# MINUTES

## Town Planning Committee

Tuesday, 2 June 2020 at 6.30pm

11.	REPORTS OF OFFICERS (COMMITTEE DELEGATION)	3
11.1	Bolton Street No 10 (Lot 24) Proposed loft addition	3
11.7	64A Clayton Street No (Lot 1) Proposed garage	13

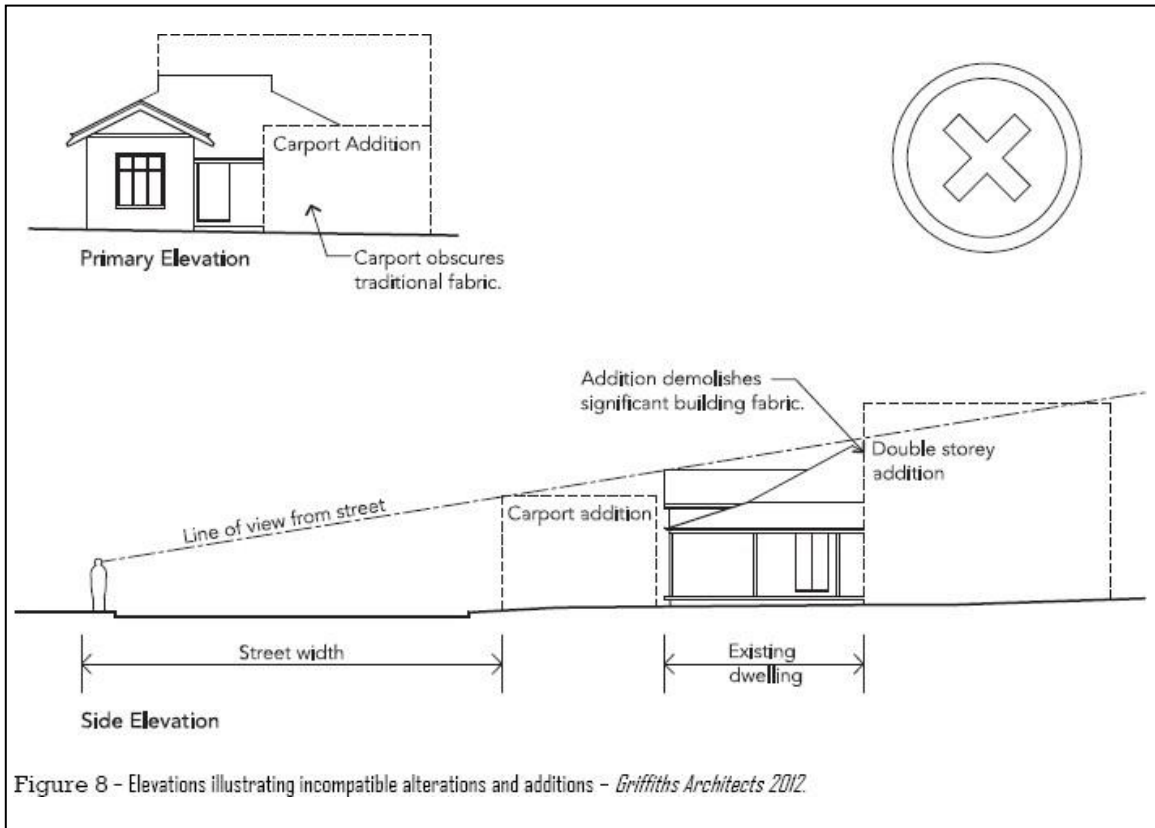
The Loft addition, as currently proposed, requires significant alteration to the outside of the building which appears to contravene the Towns own *Residential Design Guidelines*. As detailed on the submitted plans and supporting statements, the Loft addition requires an increase in roof height of 900m, a change to the angles of the existing roof line, the installation of some 25 clerestory windows on the perimeter of the “box insert” as well as modern Velux skylights on the western side of the loft.

Comparison of previous and current proposal

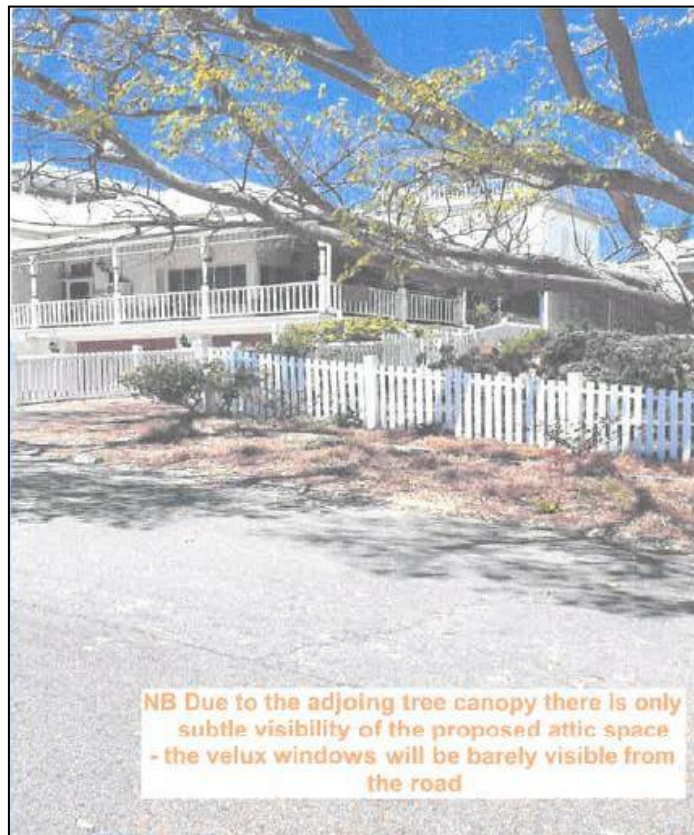
Importantly and with regard to points “a” and “b” above the revised design has actually brought the visible loft space forward via its box design and now has more prominence than the previous design as is demonstrated in the figures below.

Loft extension clearly visible from the street front, contrary to design guidelines.

Figure 1. Image from Town of East Fremantle Design Guidelines – pg 10.

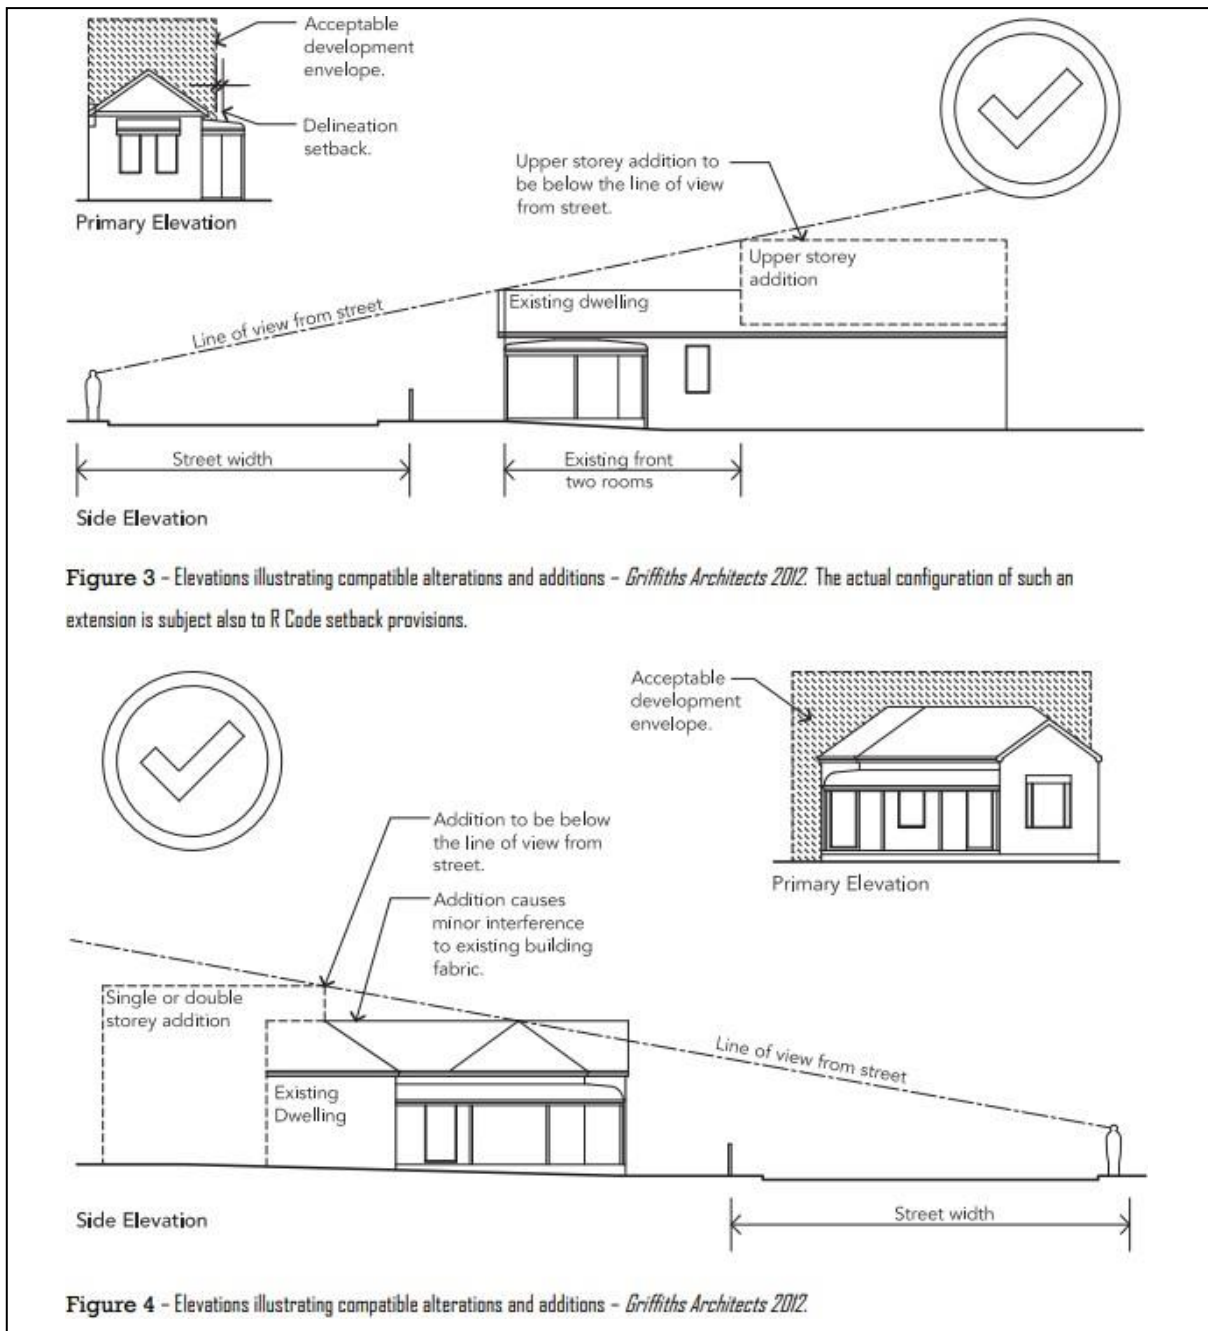
Despite the revision, we maintain the view that the current plans do not meet the required level of detail and fail to meet the guidelines of the East Fremantle Council. An example from the guidelines is provided below (Fig 1.).

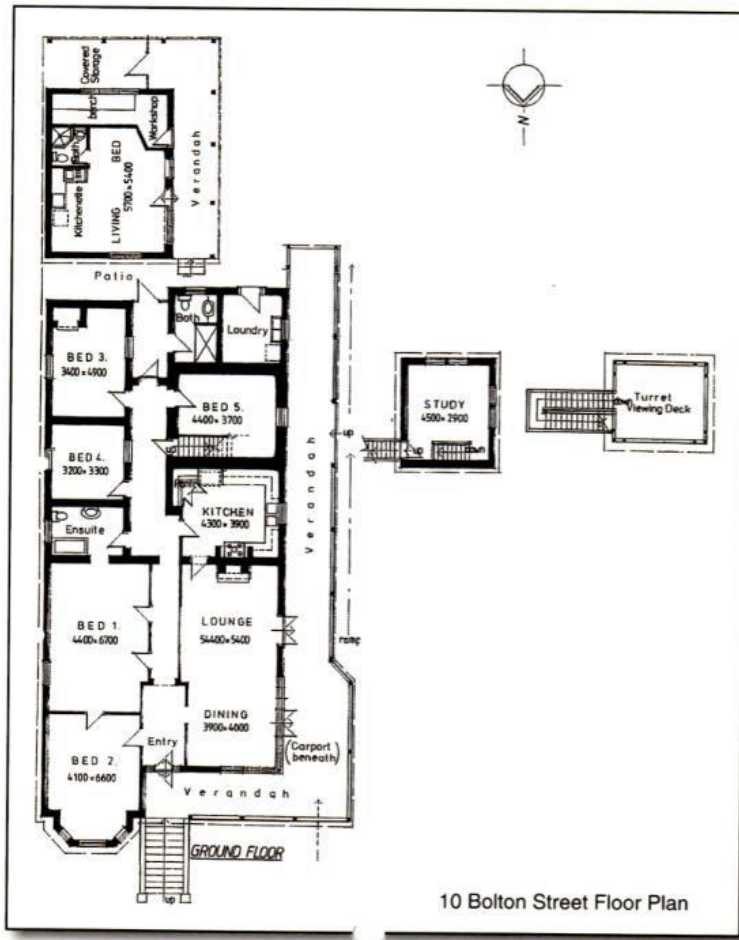
The use of the correct line of view, would clearly illustrate that the clerestory windows are visible, a significant portion of the belvedere is obscured and changes the to the roof line are very apparent.

Figure 4. Note Chimney substantially less prominent

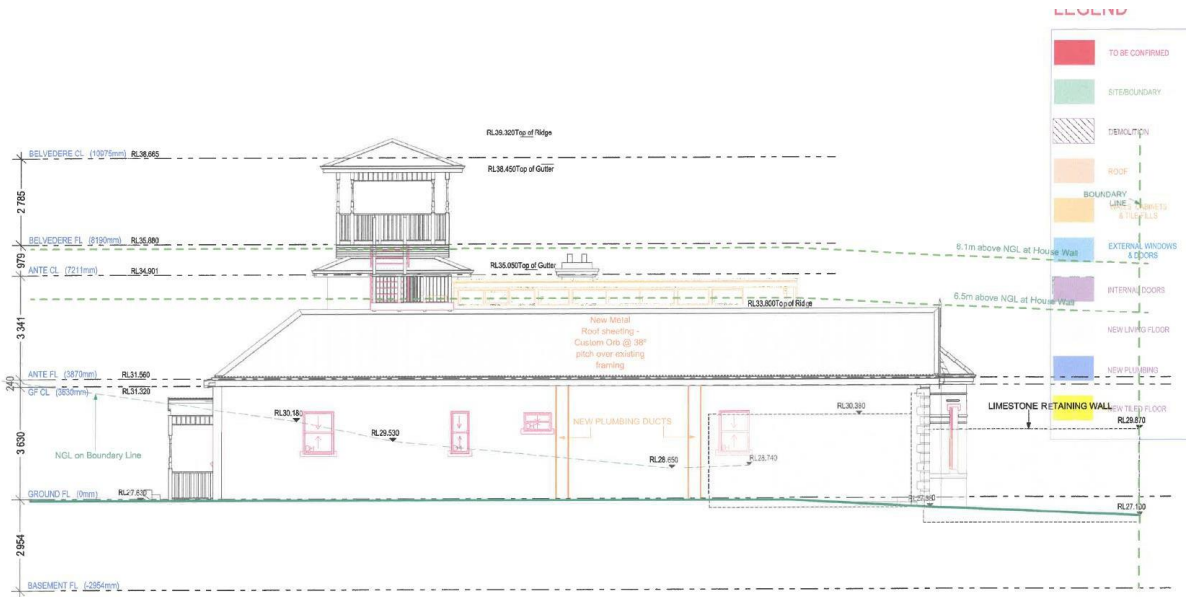
Figure 3. Roof line of 3 & 5 Bolton Street. Both show clear prominence of decorative chimneys and in the case of No. 5 significant renovation has taken place without diminishing traditional design.
